## ADDENDUM 1

**PROJECT NAME: PAPILLION LA VISTA COMMUNITY SCHOOLS - DISTRICT GENERATOR UPGRADES**

**ALVINE PROJECT NO.: 2026 2340**

SHEET NO.:  
1-0

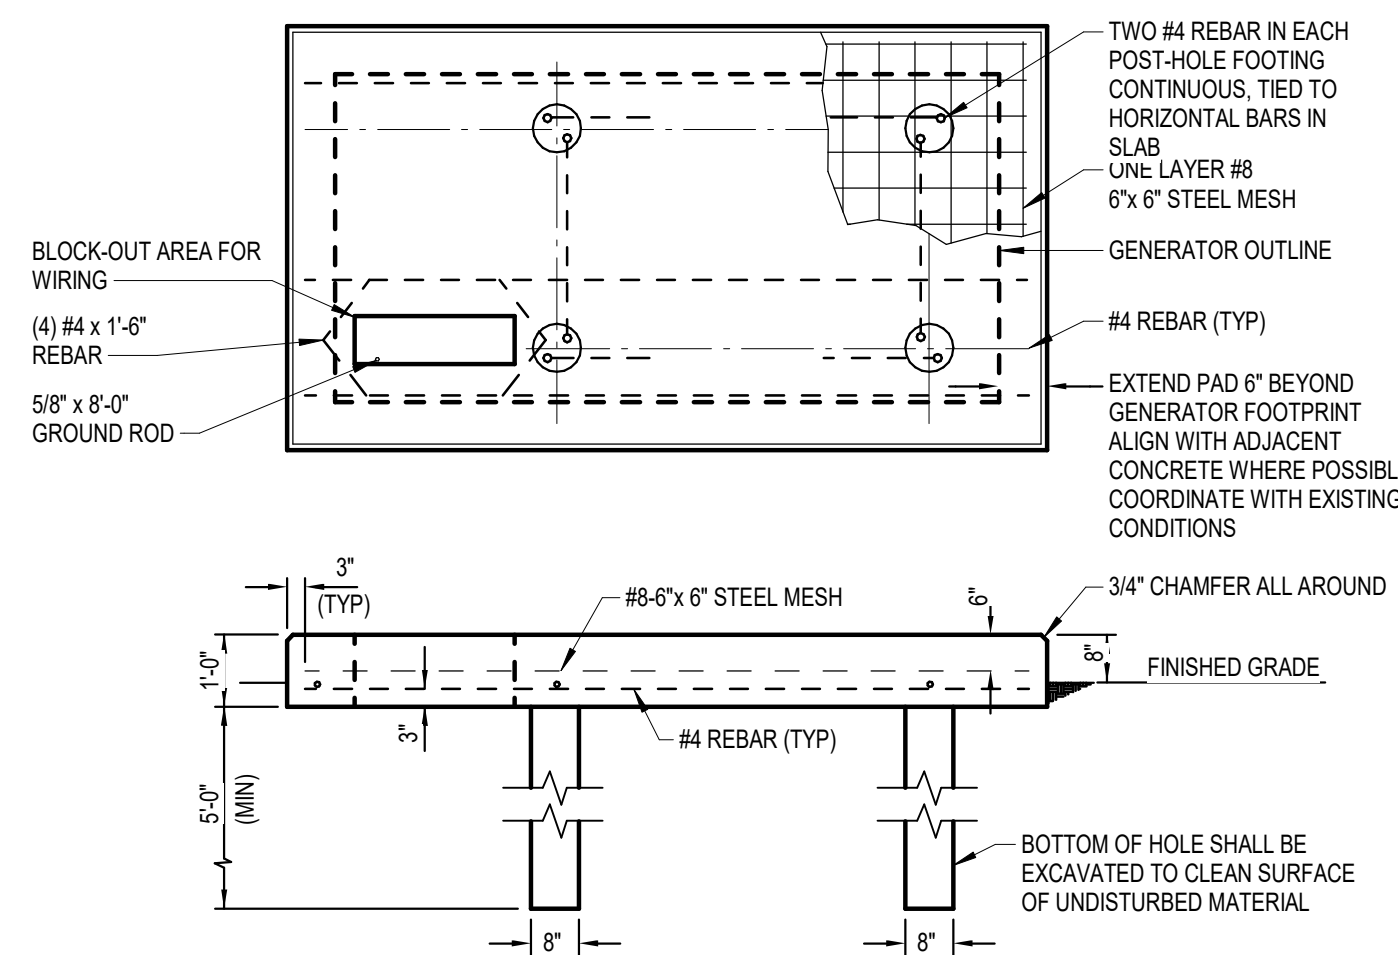
- 1ED1. Sheet 1-0 Symbols and Abbreviations
1. Add general note ‘N’.  
A. See attached reissued drawing.
- 1ED2. Sheet 2-0 Symbols and Abbreviations
1. Add general note ‘N’.  
A. See attached reissued drawing.
- 1ED3. Sheet 2-GS
1. Add bollards and modify the panel schedule.  
A. See attached reissued drawing.
